Subject: FUEL-FILLER LID PANEL IS DEFORMED	Bulletin No.: 09-023/20
	Last Issued: 08/13/2020

Some vehicles may exhibit a deformed fuel-filler lid panel (1) attached to the fuel-filler lid box, resulting in a poor appearance.

Mazda3 4-door SD (BP)
Before

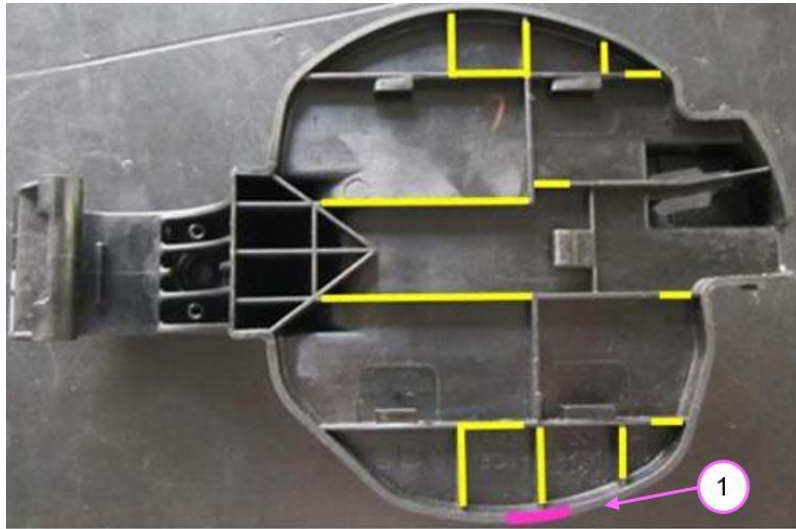
3. Cut the fuel-filler lid box ribs indicated by the yellow and pink marks in the images below.

- Be careful not to break the latches. Refer to the appendix for their location.
- Properly rework the pink-marked part (1) as this section (width of about 10 mm) is visible from the outside (2).

After

Mazda3 5-door HB (BP)

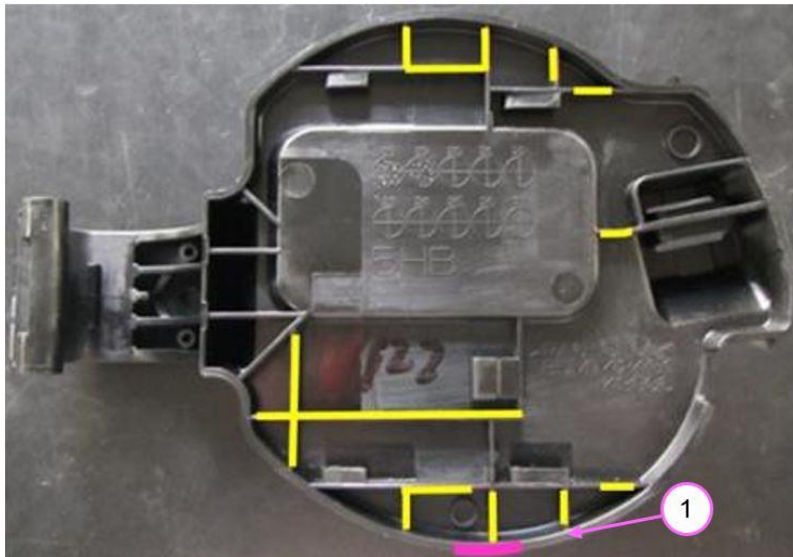
Rib cut section location for other models

Appendix: Fuel-filler box ribs cutting

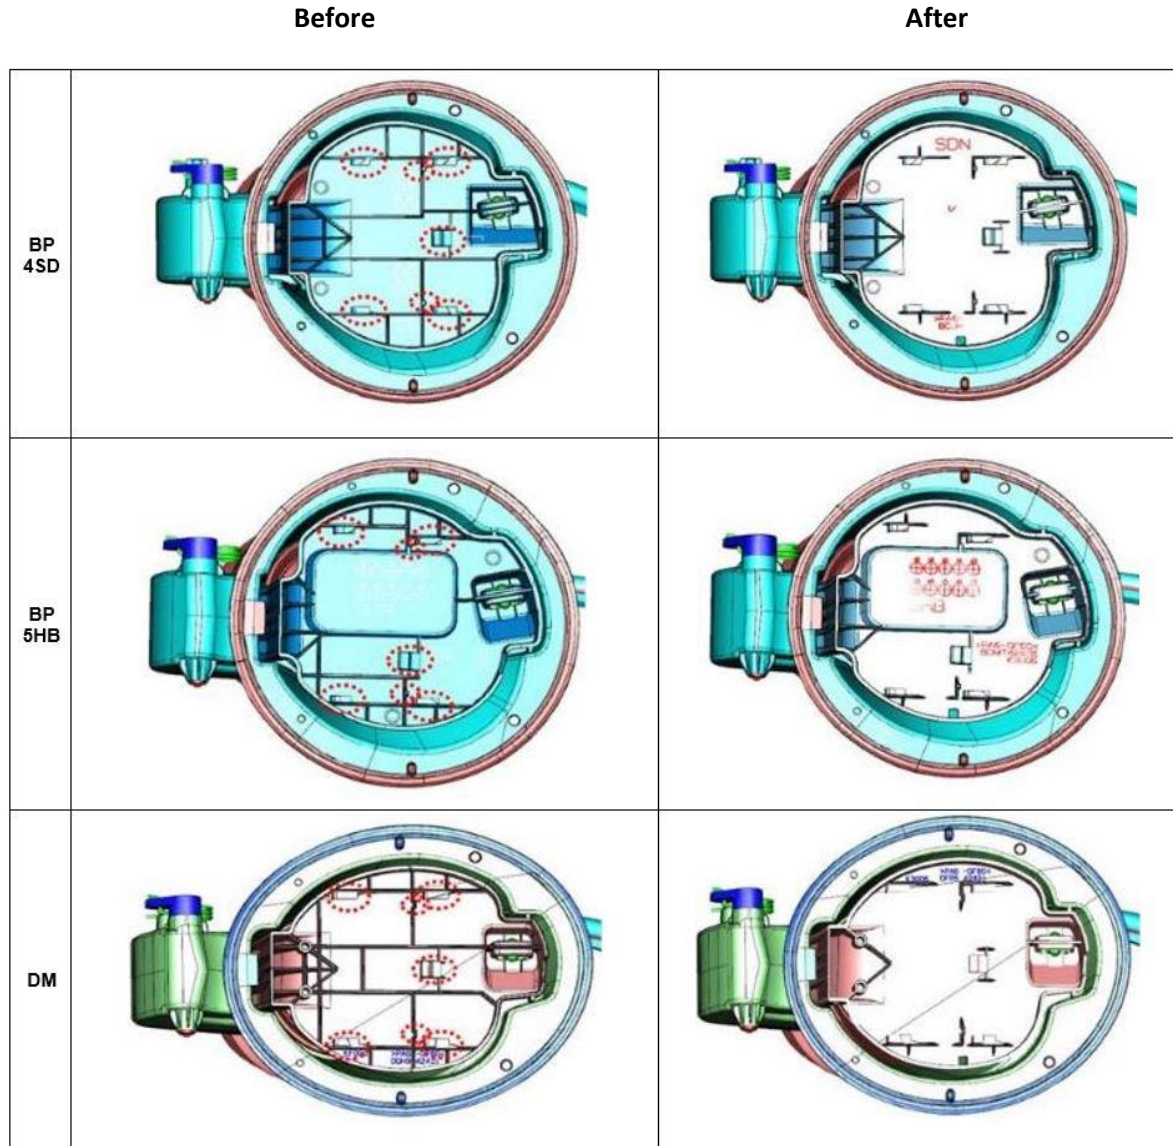
NOTE: The red dashed circles in the images indicate the latches that must not be broken.
